23.03.2023

40073-PL01\_A

**Re: Section 4.55(1A) Modification to DA 23/21 – BBQ Kitchen Facilities**  
**Site: Menindee Lakes Caravan Park (Lot 7330 DP 1195006)**

Drawing Title:  
**PROPOSED FLOOR PLAN**

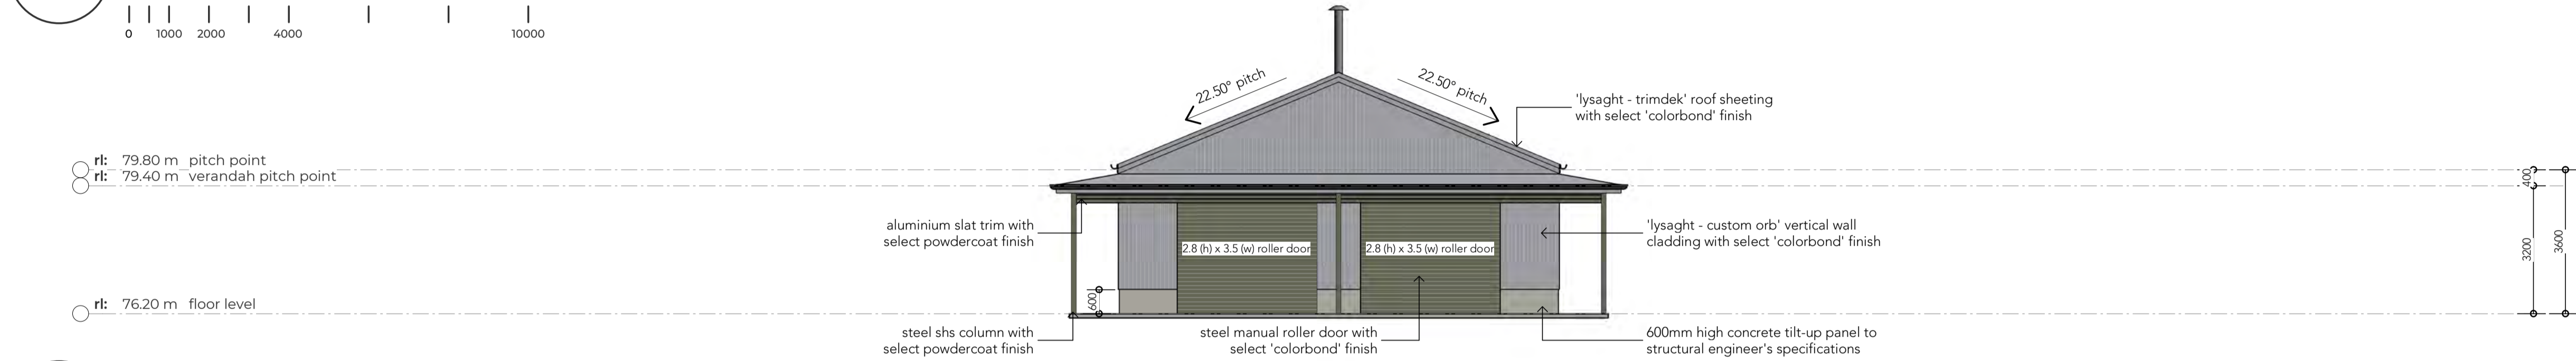
The proposed BBQ Kitchen design is proposed to change; however, the intended building curtilage shall remain in the same location. The new proposed design of the development includes the following attributes:

- o 13.5m x 13.5m footprint (approximately 182.25m<sup>2</sup>);
- o Four (4) select freestanding picnic table's with hot dip galvanised frame and timber cladding;
- o Six (6) select bolt down benches with hot dip galvanised frame and timber cladding;
- o Four (4) 2.8 (h) x 3.5 (w) manual roller doors;
- o Two (2) PA doors;
- o 200mm high stone masonry plinth with steel brazer and flue
- o 'lysaght – custom orb' vertical wall cladding with select 'colourbond' finish
- o 600mm high concrete tilt-up panel
- o 'lysaght – trimdek' roof sheeting with select 'colorbond' finish
